City of Bainbridge Island

## **Fletcher Landing Proposed Road End Improvements Assessment**

**Date:**

September, 2014

FIGURE 7  
OPTION A

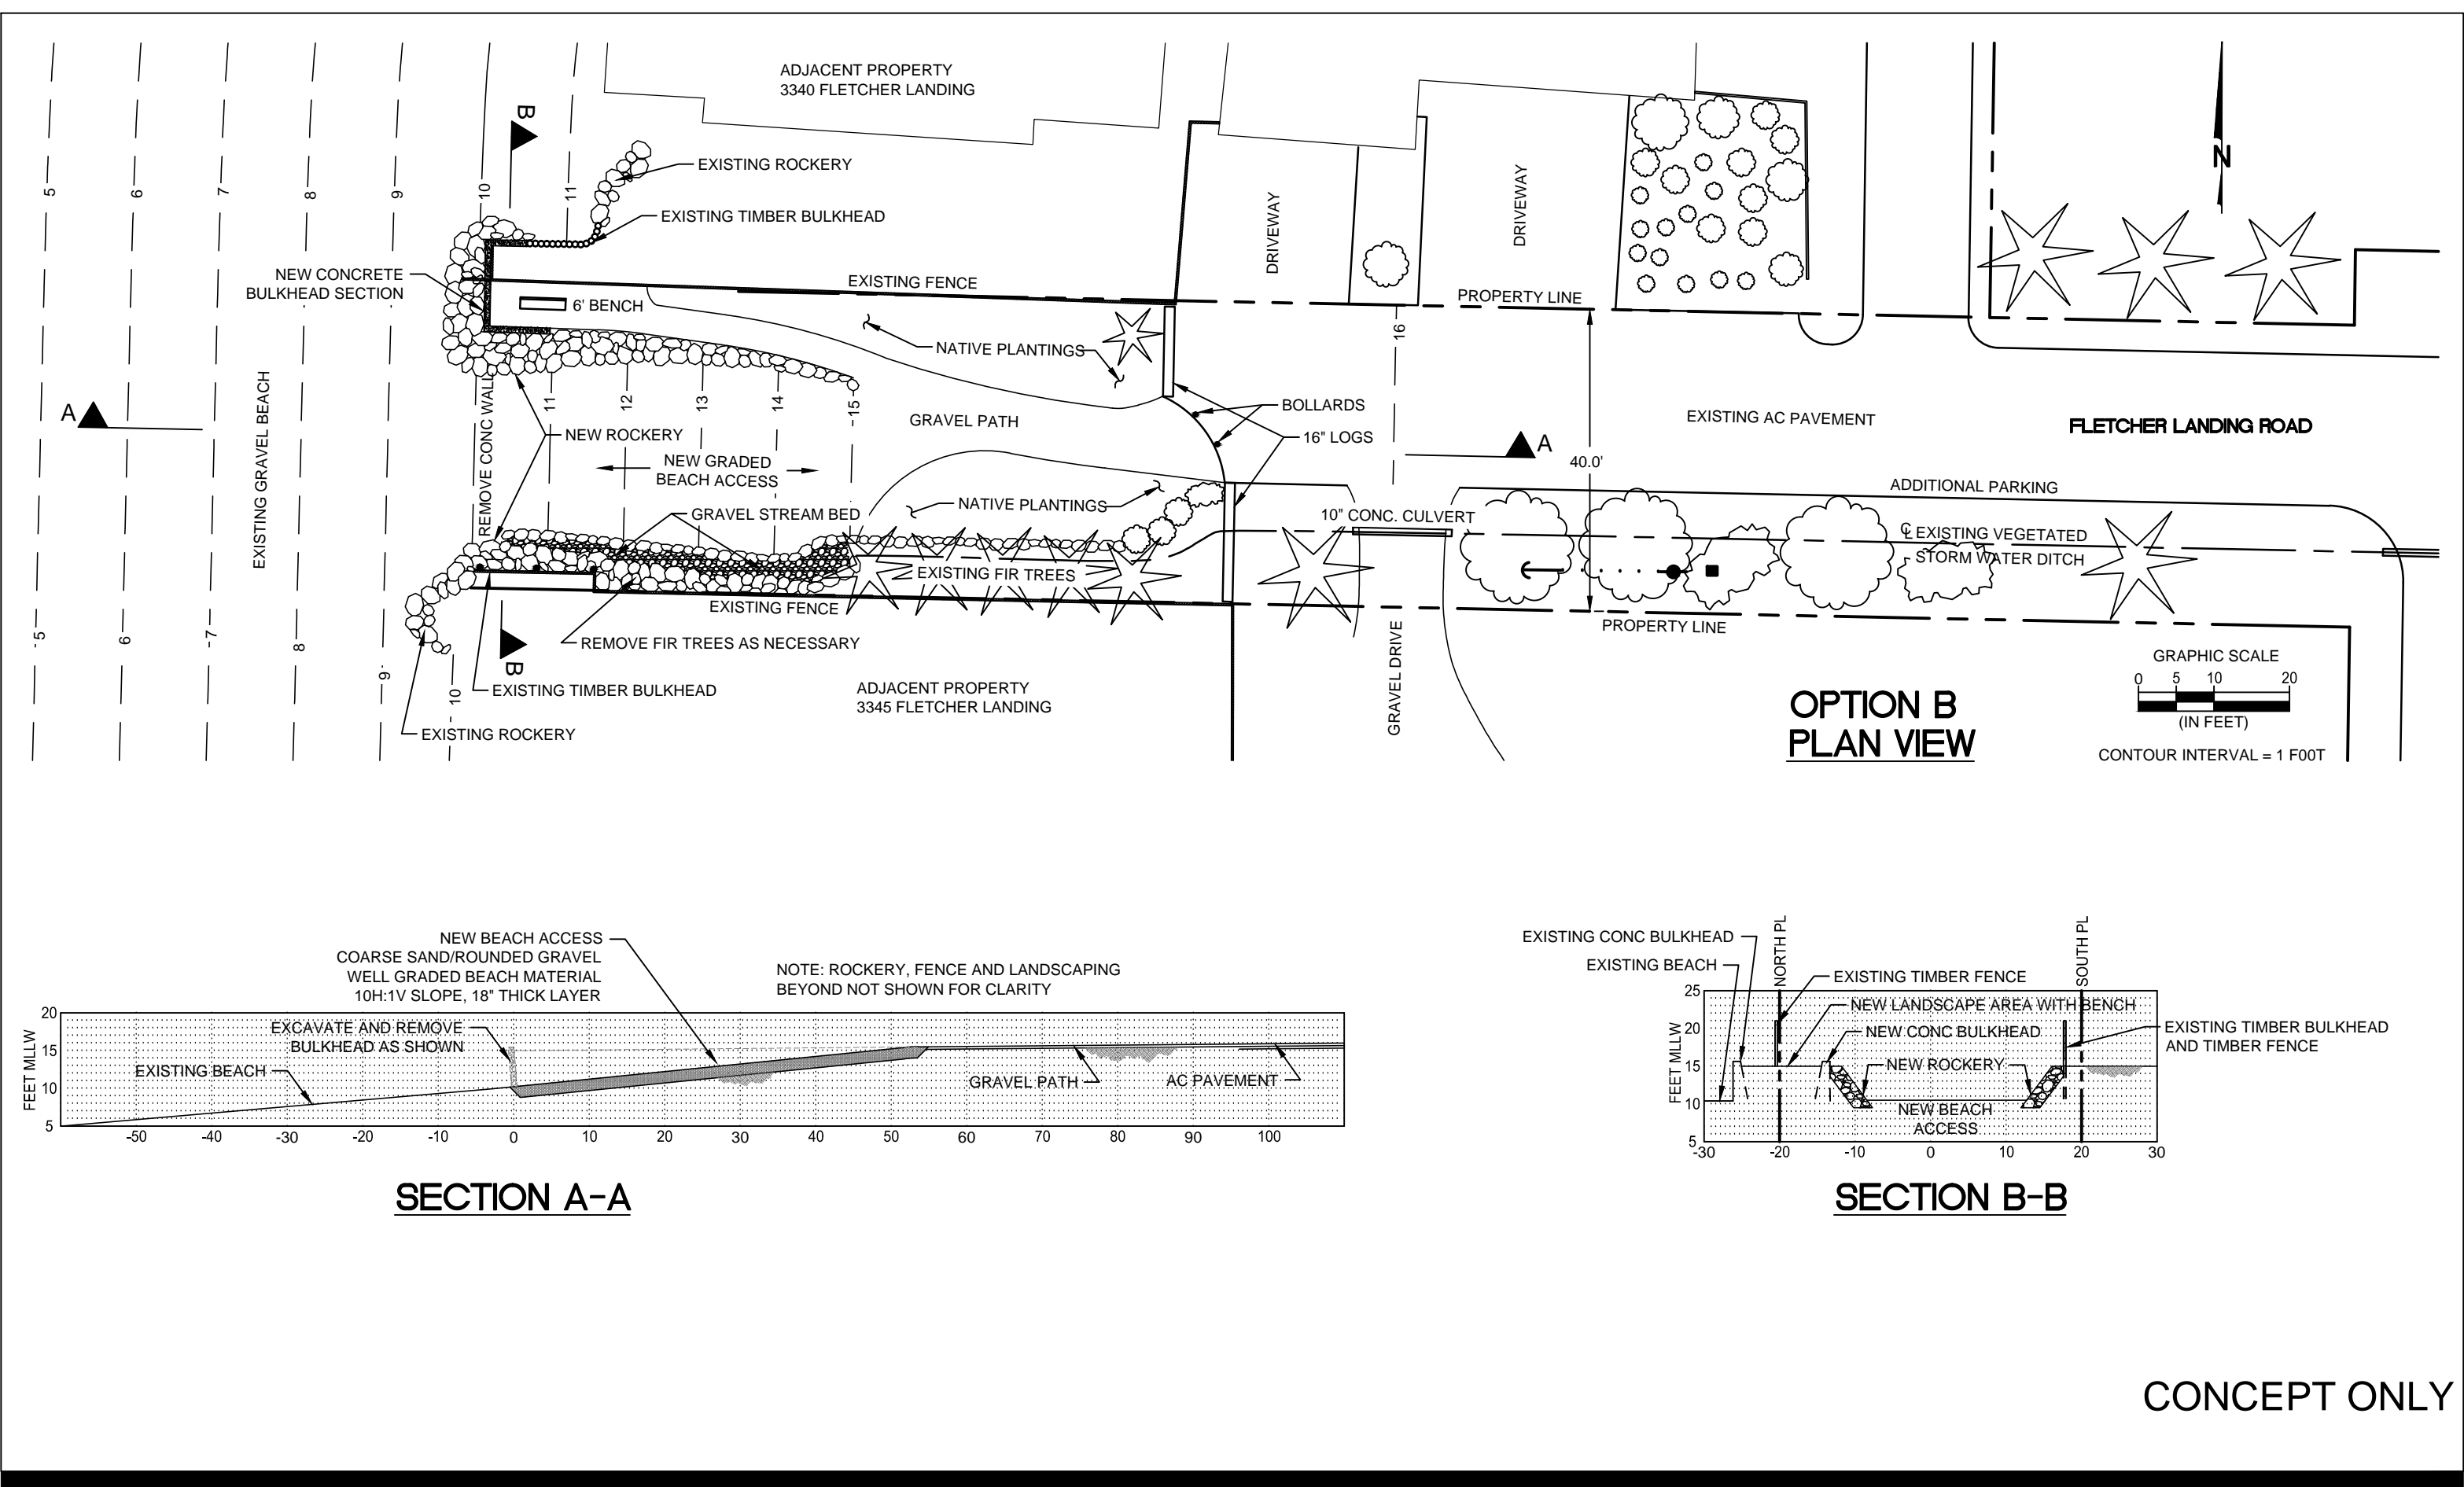
This option (Figure 7) provides the widest beach access with limited new upland landscape areas. The bulkhead is removed from the northern property line to its southern end. Existing grade is excavated to provide beach access by

carrying the existing beach up slope to tie into the existing upland elevation, creating additional beach area. Concept drawings show this beach extension at an approximate 10H:1V slope (final stable slope determined in design). It is assumed that material for the new extension of beach will be sized appropriately to blend with fronting beach and remain stable. Thickness of the new beach material layer is assumed to be 18 inches. New stone rockeries will protect the cut slopes along the north and south margins of excavation and tie into existing rockery to the south and bulkhead to the north.

This concept basically creates a well-protected pocket beach. Considering elevation range of new access beach and level of protection, erosion/stability of beach profile is not anticipated to present a significant design issue (for any of the options). Demolishing the seawall removes a vertical structure from the upper intertidal zone; this should provide some limited improvement in erosional conditions during the higher water levels by eliminating a reflecting surface for wave energy. No negative impact to adjacent shorelines would currently be anticipated (for any of the options).

Stormwater management for this option includes transitioning from the current open ditch to an 8 inch buried line at the 10 inch driveway culvert. The new pipe would enter a new catch basin with insert and then a buried discharge line extends west down the new access ramp and out to a beach discharge point at approximately elevation 8 feet within the intertidal zone. Additional more detailed design analysis is necessary to determine the area drained and amount of water to be conveyed during a design storm, and to determine the feasibility of an open vegetated bio-swale type system. Discharge at the rockery with an energy diffuser should also be explored as an alternative to the beach discharge.

This option provides two parking spaces as part of the street end redevelopment and, as with other options, there is room to park up to 4 vehicles along the south side of the road east of the gravel driveway.

Option A maximizes beach access and has the lowest level of park like amenities and landscape features. Maintenance for this alternative is anticipated to be minimal.

There is a large monolithic concrete remnant at beach grade in front of the existing bulkhead, with a rebar stub protruding in at least one location. The full extent and depth of this concrete is unknown, as it is partially and intermittently covered. It is recommended for all options that this be left in place (with any protruding steel cut off) and design provided such that it is covered with 12 inches of material similar to the existing beach.

This alternative (as depicted) brings excavation and rockery construction right up to, or very close to, the adjacent property lines and property owners' fences. Lacking information on fill/sub-grade material appropriate measure should be taken in design and construction to insure the integrity of fences and adjacent properties is maintained.

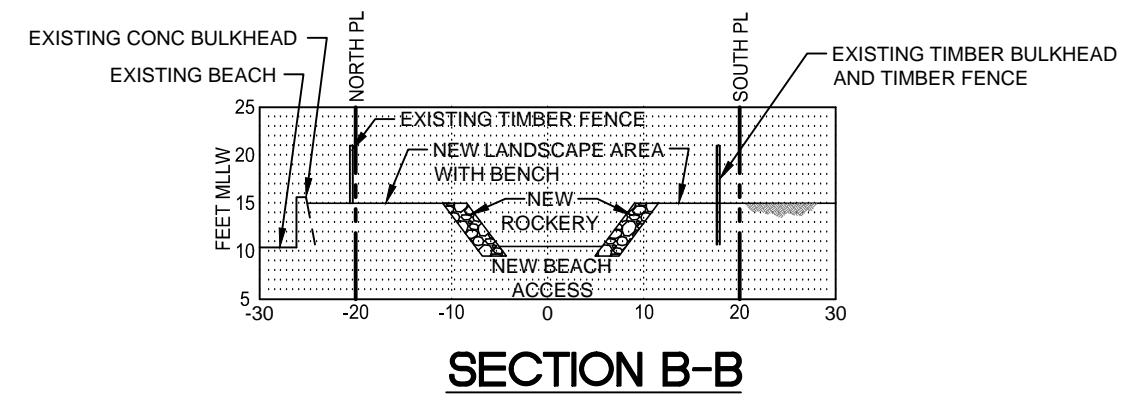
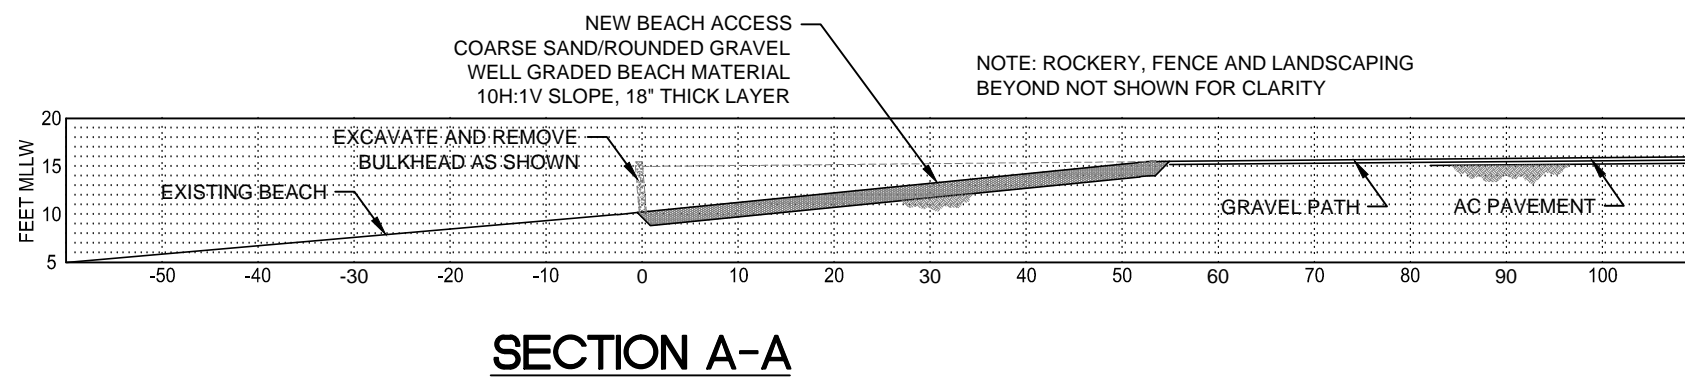
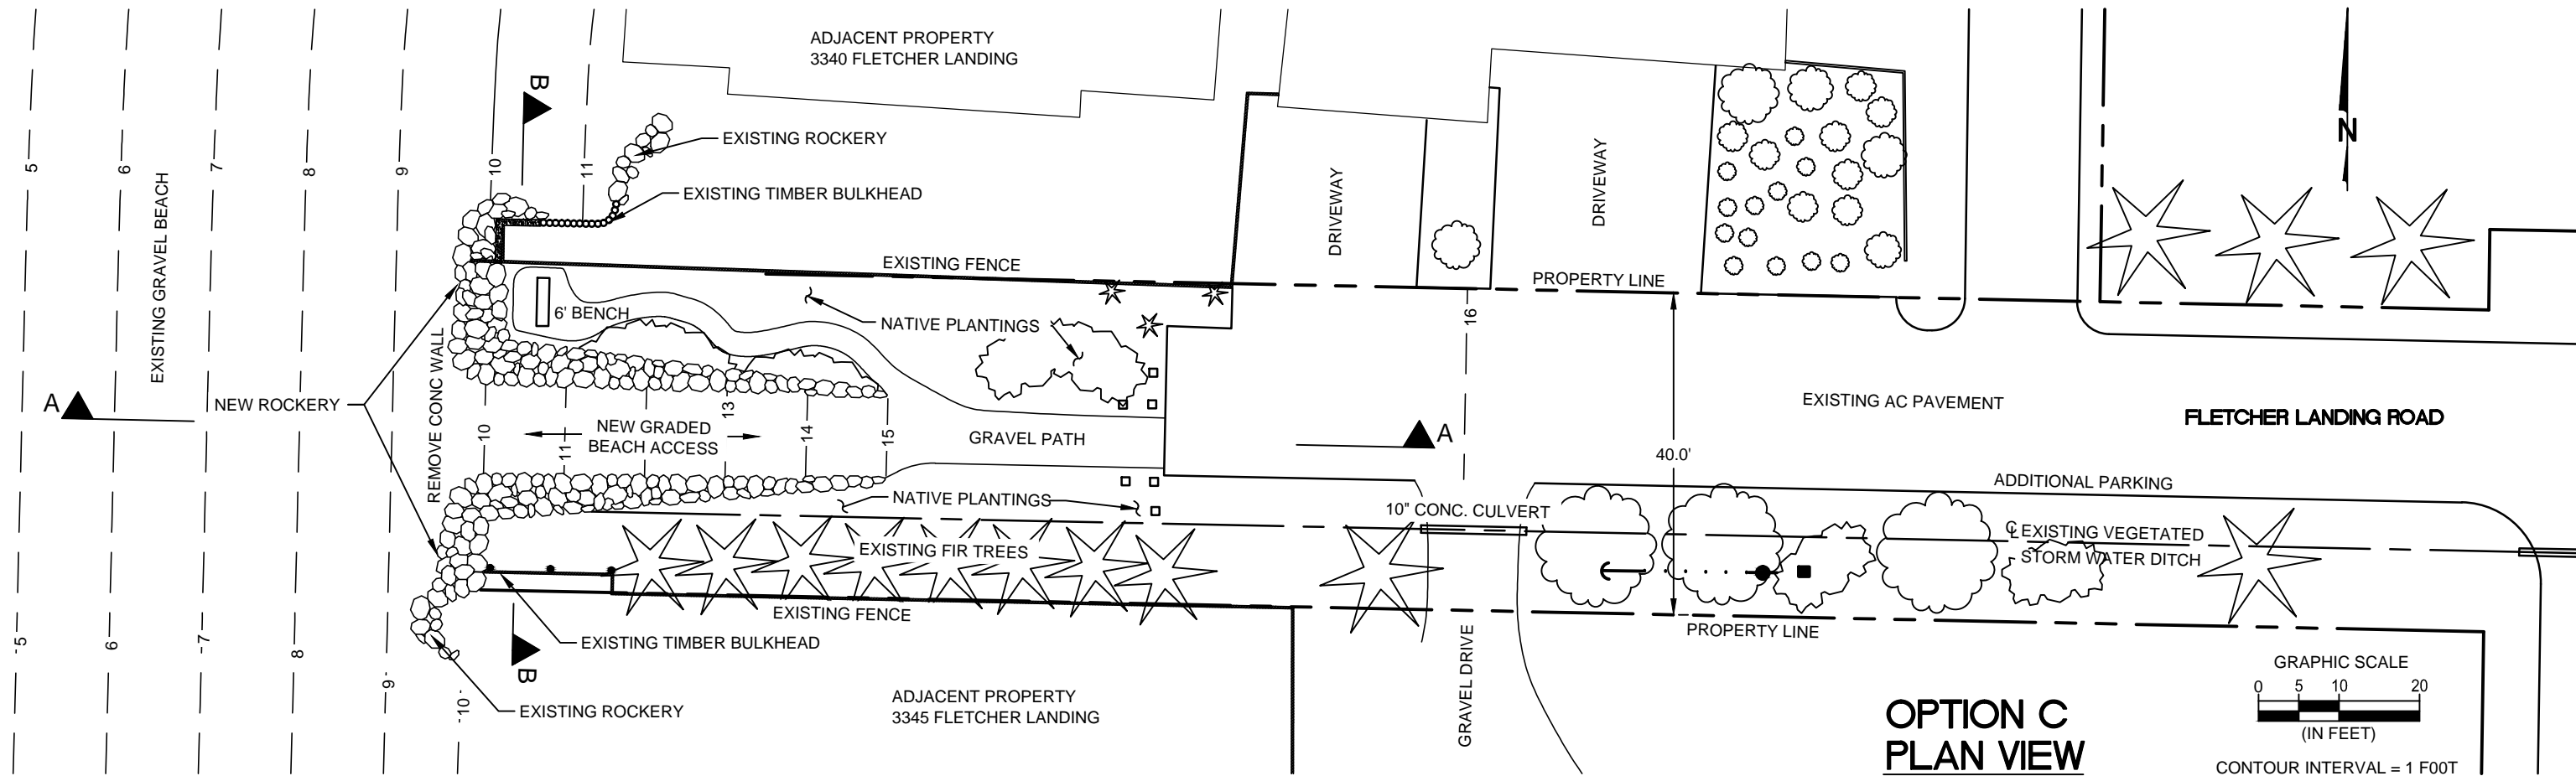
Option B (Figure 8.) follows the same basic concept as Option A but reduces the width of the beach access and provides a narrow landscaped area with a path and viewing bench at an upland grade along the northern edge of the site. A concrete bulkhead is constructed at the shoreside end of the viewing area.

Based on the concept sketch, it appears that Option B transitions the open stormwater ditch into an artificial gravel stream bed integrated into the rockery close to its base and discharges to receiving water. This is an interesting feature, but as with the other options, additional more detailed design analysis is necessary to determine the area drained and amount of water to be conveyed during a design storm, and the feasibility and compliance of the concept.

The concept sketch showed no parking spaces being created at the new street end but as with other options there is room to park up to four vehicles along the south side of the road east of the gravel driveway.

Option B reduces beach access width in order to provide a minimal level of park-like amenities, a viewing bench and landscape features. Maintenance for this alternative is anticipated to be minimal, limited to the care of landscaping.
